CITY OF PORTLAND BUILDING PERMIT

PERMIT ID: 2013-00162

106 SKYLARK RD

has permission to **New 48' x 40' two story colonial with 465 sf attached garage.**

GREAVES RESIDENCE
 106 SKYLARK AVE., PORTLAND, ME.
 DRAWING FLOOR PLANS

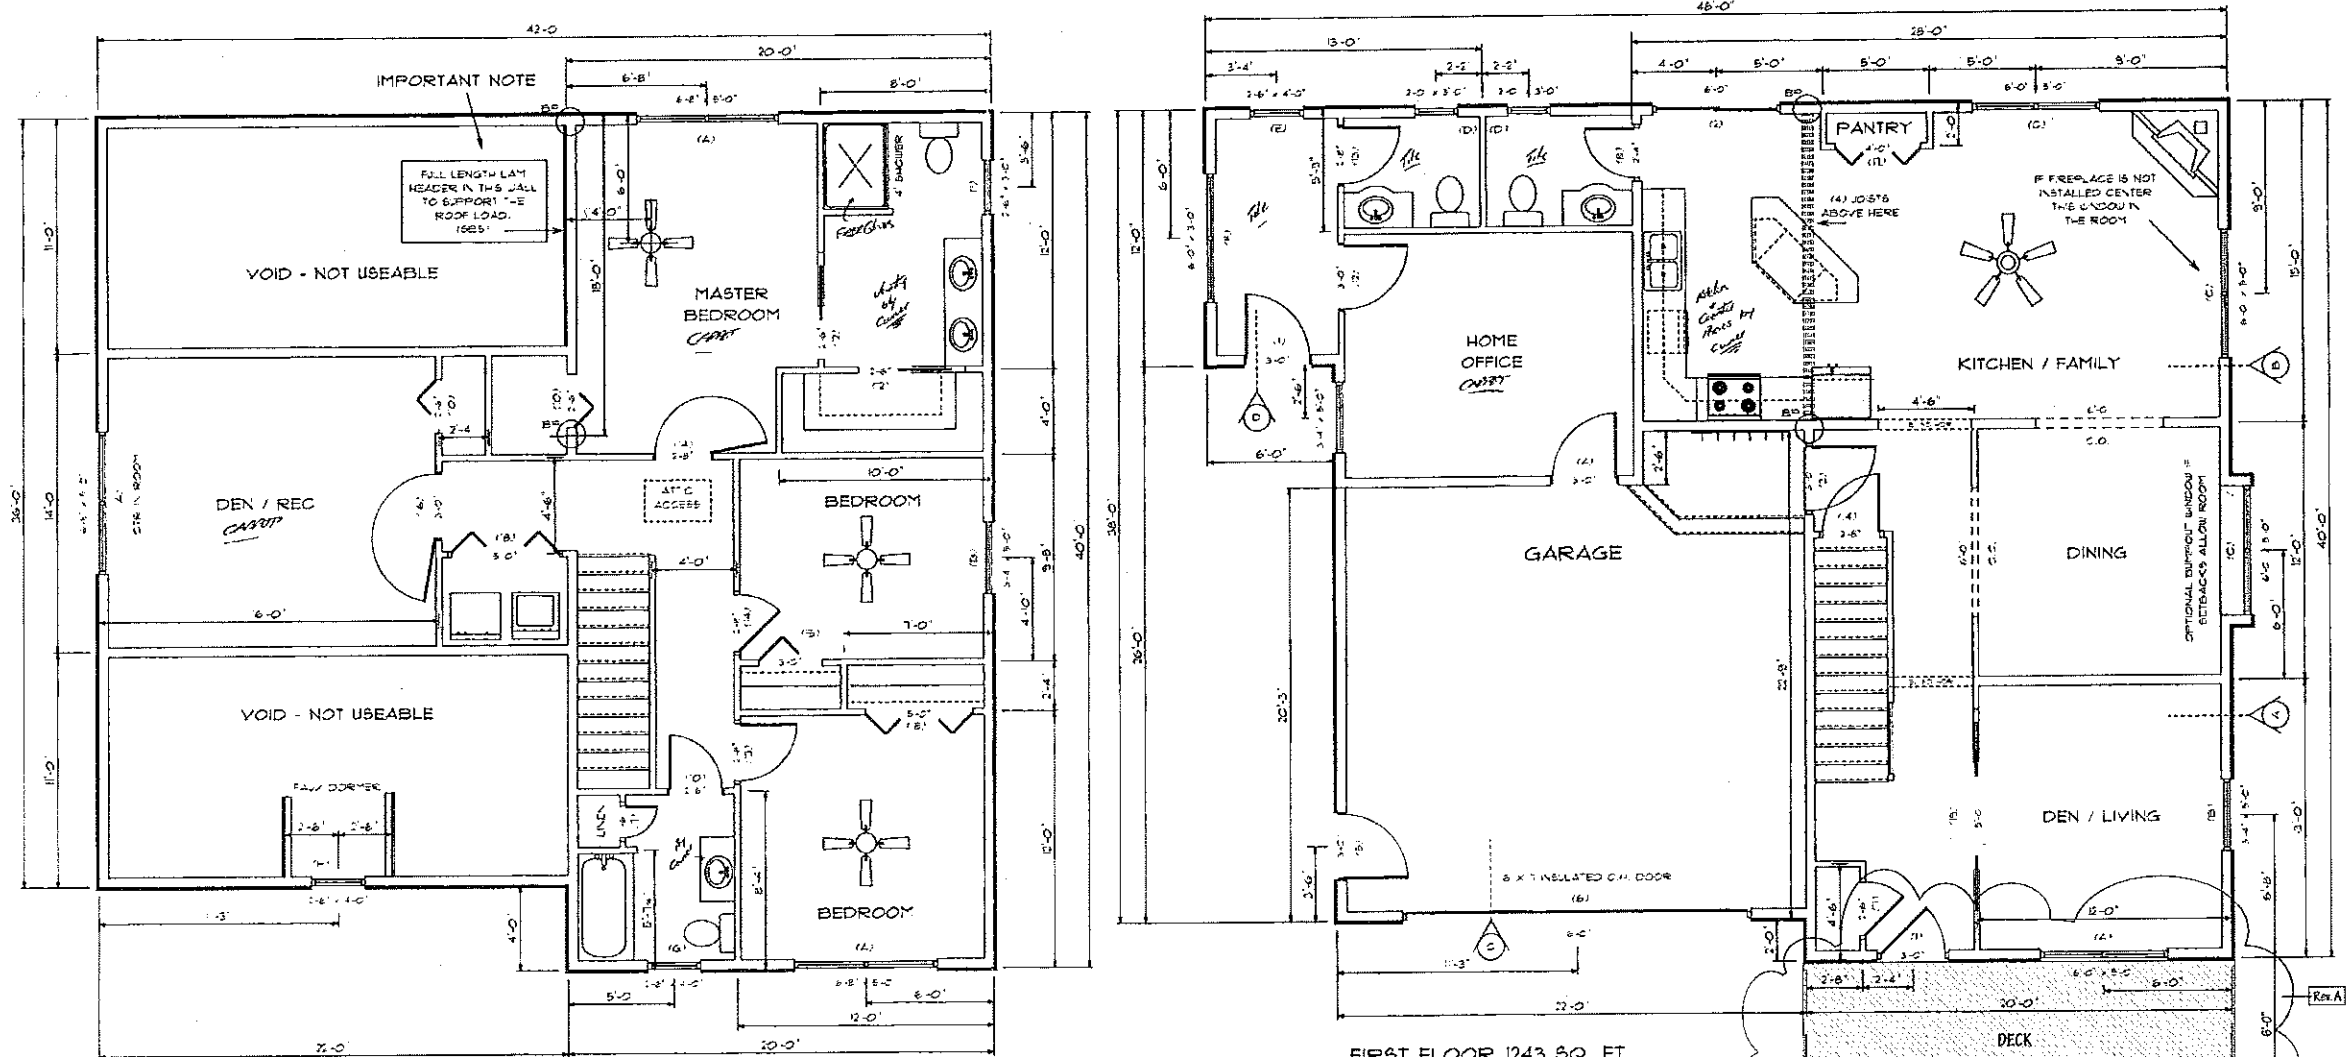
Finished zoning review. Need a copy of Jennifer Fowler -Greaves deed. Recorded deed will have to follow the format for all deeds for this subdivision. Floor plans for first floor does not show the footprint of the porch.

Received revised site plan that shows bulkhead. Received revised floor plan that shows the porch (deck) on the first floor plan. Received copy of Jennifer Greaves' deed. The proposed bulkhead encroaches into the PWD easement. Need something in writing from the PWD stating that this is OK. Will need recorded deed that exactly matches the deed required by the subdivision before the certificate of occupancy is issued.

SITE PLAN-LOT 14
SKYLARK COMMONS
SKYLARK ROAD AND COOLIDGE AVENUE
PORTLAND, MAINE

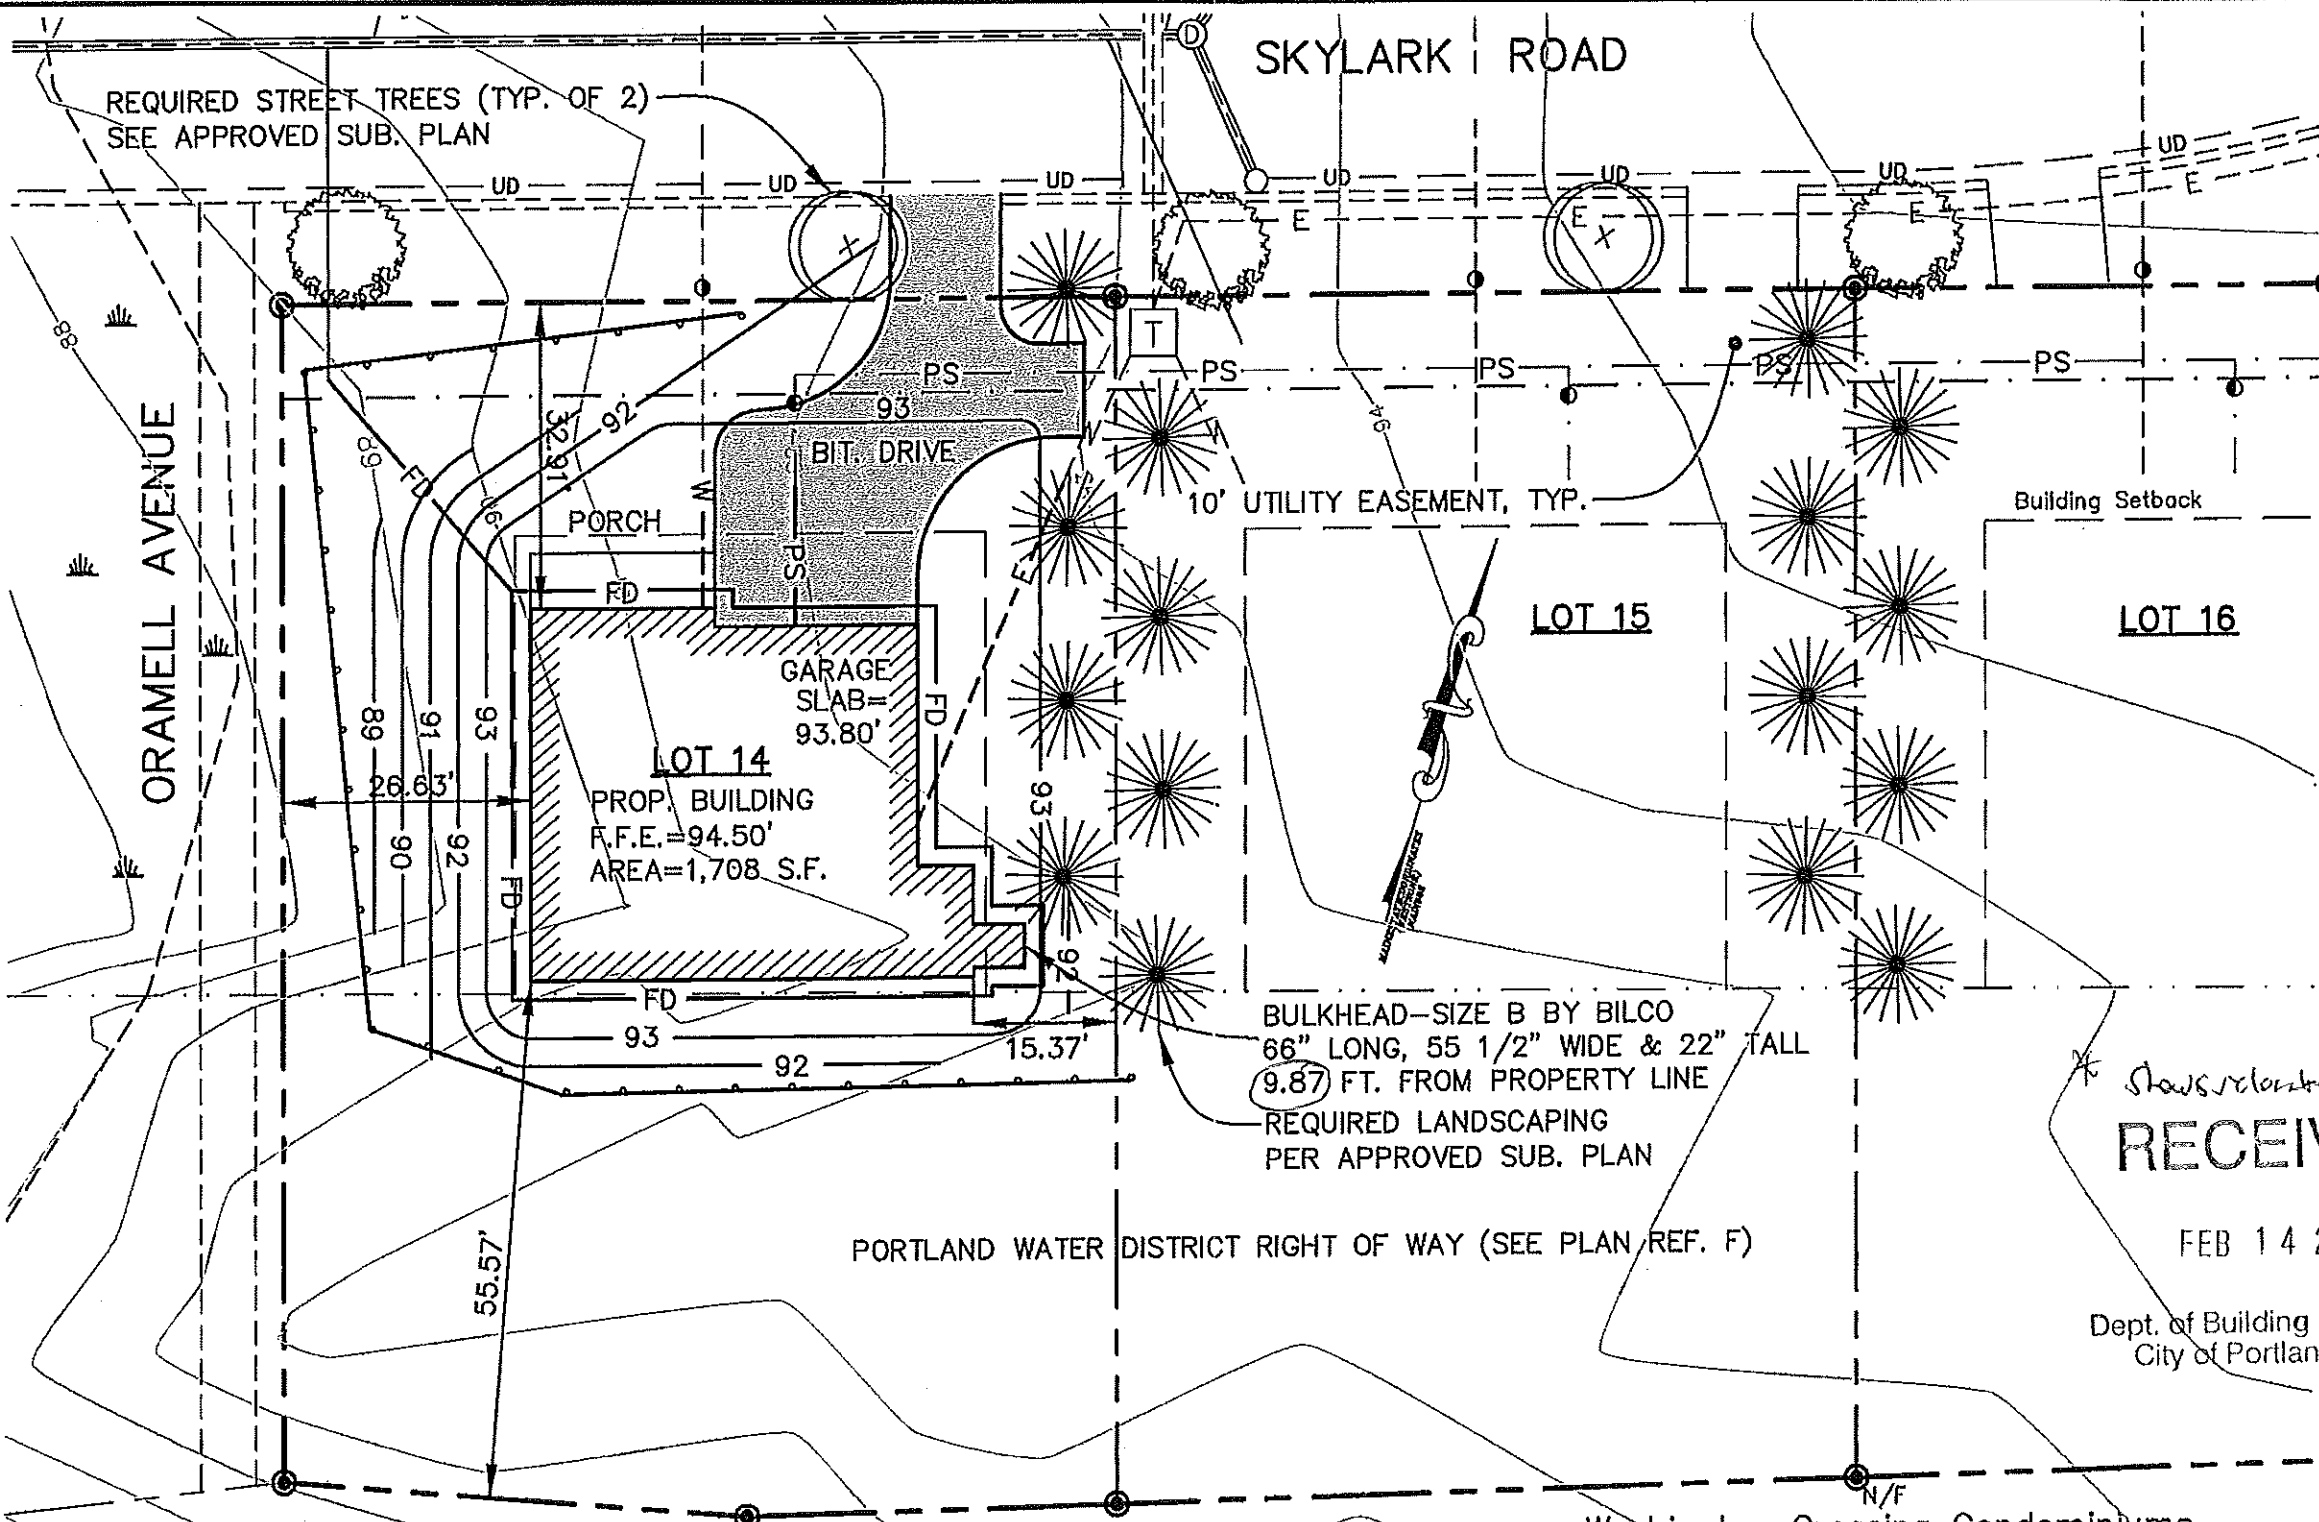
As far as the bulkhead and porch go, the bulkhead will have to be added to the site plan. If you cannot get a hold of J. Call, you can submit drawings that show the bulkhead on the foundation and the front porch on the floor plan for the first floor.

- Note #2 was revised with the correct Applicants name
- Note #1 was revised with the correct owner's name
- Note #6 was revised with the correct deed reference
- Note #7 was revised with the correct tax map reference
- Please make the City aware that all of the property corners for this lot have been set by our office. The Building setback corners for this lot have also been staked out by our office.
- Note #19 was revised regarding street status
- The distances from the proposed foundation to the property line was shown on each side of the house as requested.
- Please inform the City that our office is submitting the revised plan to PWD for their input and acceptance of the proposed work within the existing easement.
- Note #20 was added to the plans regarding soil type
- The bulkhead was added to the plans as you requested.

changes to this plan. Once you have endorsed the plan I will send it along to PWD. Please note that the addition of the bulkhead falls within the PWD easement along the Southern portions of the site. The PWD may not allow this structure to be located within the easement. I will work with PWD on this issue. Thanks
